TO: Sydney Central City Planning Panel

SUBJECT: 51 Rawson Street AUBURN NSW 2144

APPLICATION No: DA2021/0132

Issues	Heritage, variation to maximum building height, submission

Figure 4 – CDEP markup of amendment (Source: A. Raadik, 2021)

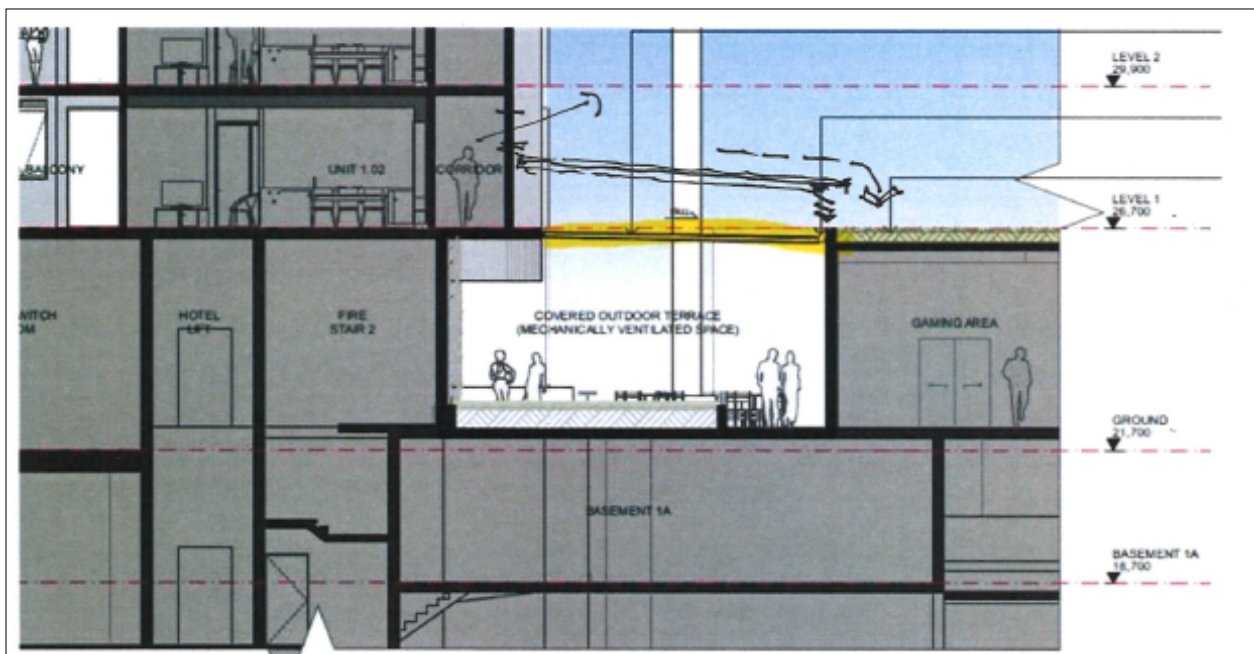
- 2. The courtyard space that has changed from being a new laneway to an outdoor bar for the hotel is supported, but the quality of space for an enclosed area would benefit from additional height to create a better volume relationship with the Hotel.*

- 3. The glazed roof over the outdoor is beneficial but an increased height of the space would be recommended (restricted to below the hotel roof apex) to create a more voluminous space that would acknowledge the separation between the tower and hotel masses as was the original intent.*

- 4. While the outdoor bar space is also noted as mechanically ventilated, with a loftier height this may allow some partially louvred solution for a passive ventilation option subject to addressing any acoustic issues.*

Council sought additional advice in relation to a condition of consent to address items 3 and 4 above. The CDEP provided the following sketches, which has been translated into a recommended condition of consent requiring the glazed roof over the covered outdoor terrace to be raised to provide a minimum 4.8 metre height from ground level and to slope from under the sill of the corridor windows to the green roof of the outdoor gaming area, to ensure there is good run-off for collected rainwater and scope for the introduction of adjustable louvres in the vertical face.

A condition of consent requiring amended architectural plans to address the above, prior to the issue of any Construction Certificate has been included in the recommended conditions of consent at **Attachment 1**.
